Monthly Specification Update

Intel® Server Board S5000PAL

Intel Order Number D65289-036

October 2011

63. Hard Disks Are Difficult to Install in Intel® Server System SR2500AL and Intel® Server Chassis SR2500

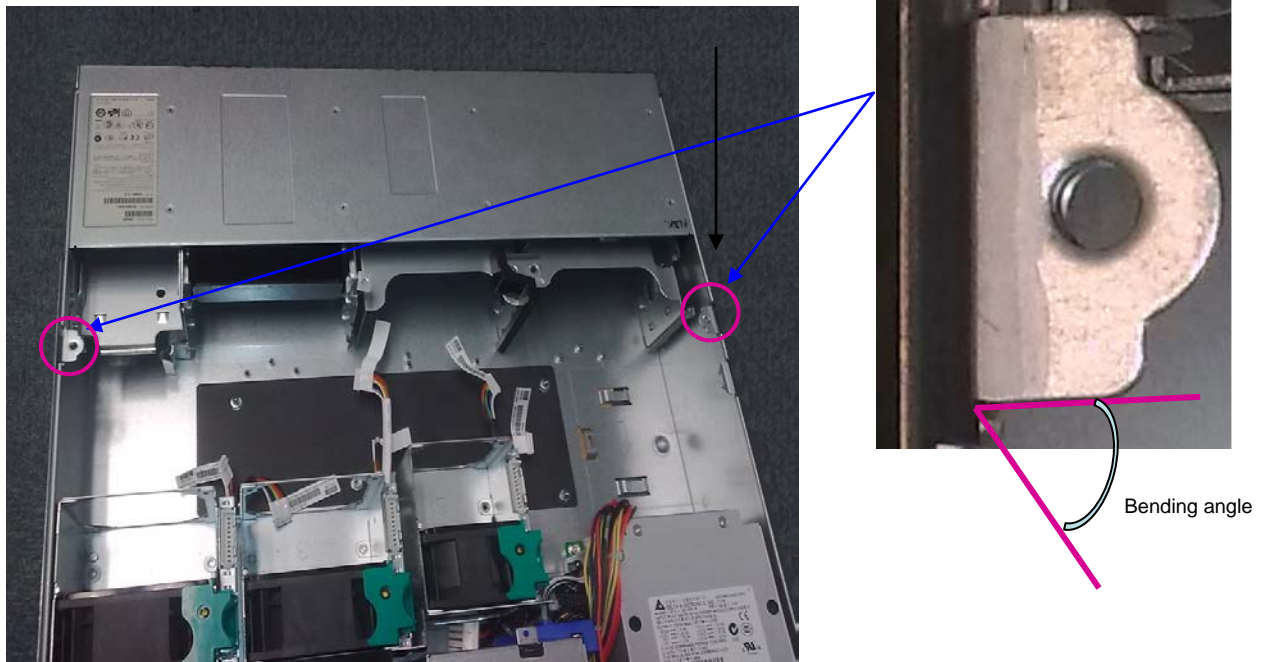
Problem	Customers may find it difficult to properly and fully install the hard drives into the hard drive slots. This is because the backplane is about 0.5-1.5 mm vertically higher than the specification.
Status	This erratum has been fixed.
Workaround	Check to ensure the bottom of the backplane touches the chassis base. If there is an obvious gap, check the two bending features (shown below) and make sure the bending angle is no more than 90 degrees. If necessary, use flat-nose pliers to bend these two features down to lower the backplane. Contact your local Intel Customer Service for more information.

1. The SMBUS block diagram (Figure #16) provided in Rev. 1.1 of the Intel® Server Board S5000PAL/S5000XAL TPS requires changes to accurately reflect production hardware design

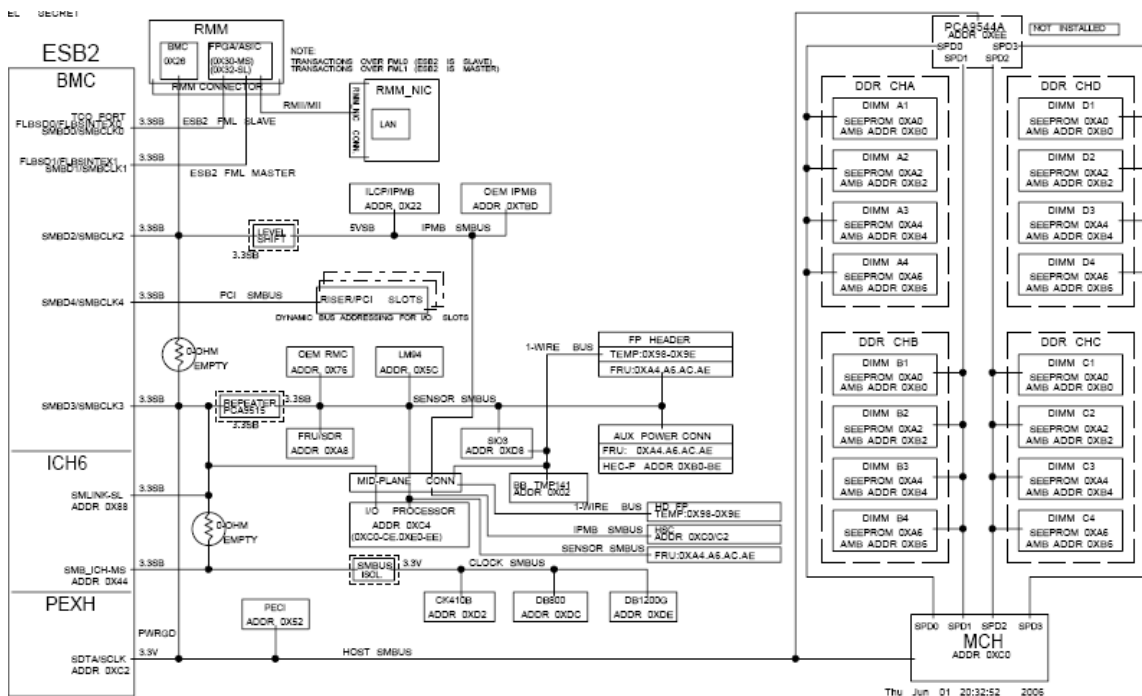
- Add PECI controller
- Remove separate HSC connector
- Correct Midplane -> FP SMBus connections and 1-wire temp sensor
- Correct SMBus and 1-wire temp sensor connections to FP connector
- Correct FBDIMM labeling

The corrected diagram is shown:

2. The power block diagram (Figure #25) as provided in Rev. 1.1 of the Intel® Server Board S5000PAL/S5000XAL TPS does not reflect the final, production-level baseboard design

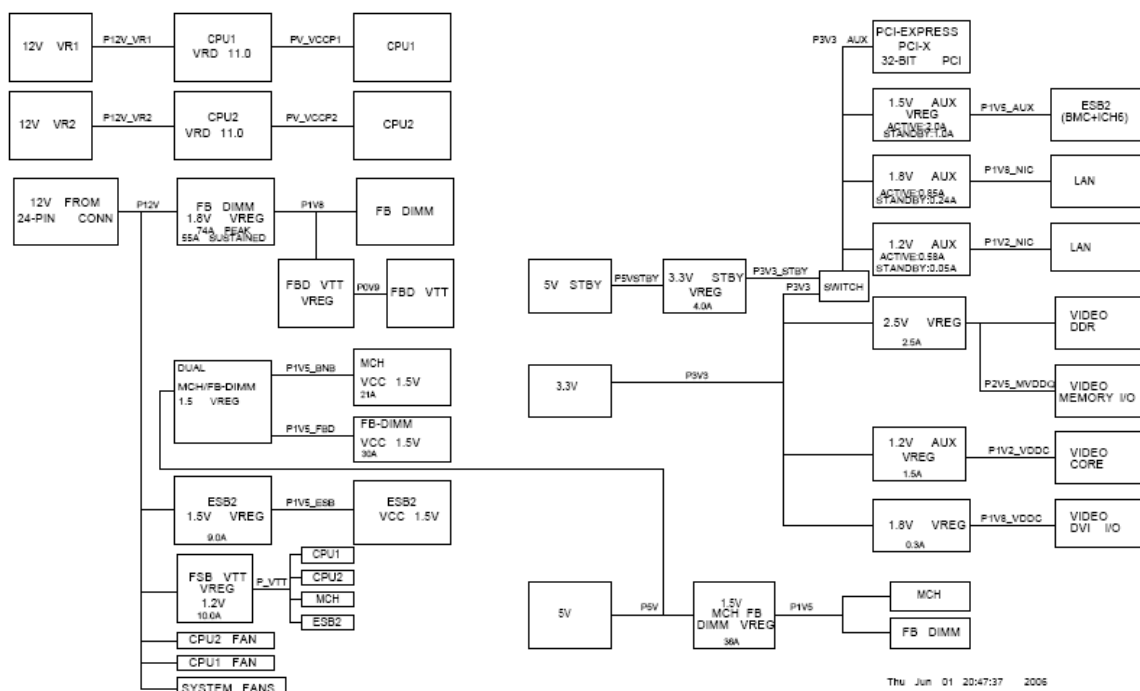
- MCH/FBDIMM 1.5 Vreg moved from 12 V rail to 5 V rail.
- Video Memory Vreg corrected to only one 2.5 V reg. instead of two.
- “ATI” label for Video components changed to generic “Video”.

The corrected diagram is shown:

Figure 22. SAS/SAS RAID Mid-plane Board

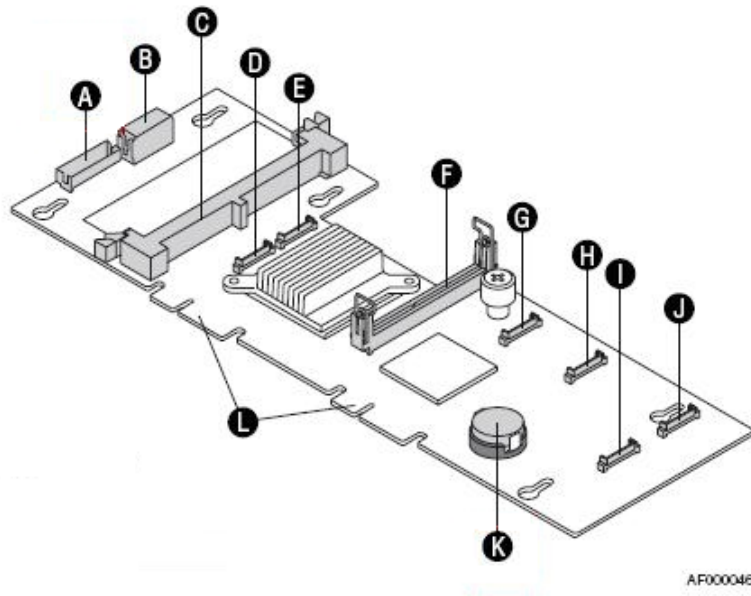
3. SAS/SAS RAID midplane board (Figure #22) as provided in Rev.1.0 of the Intel® Server System SR2500AL TPS should swap the descriptions of items A and K

A	Battery	G	Fan 4 Connector
B	Power Connector	H	Fan 3 Connector
C	Mini-DIMM Connector	I	Fan 1 Connector
D	Fan 6 Connector	J	Fan 2 Connector
E	Fan 5 Connector	K	RAID Activation Key
F	Bridge Board Connector	L	Backplane Connector
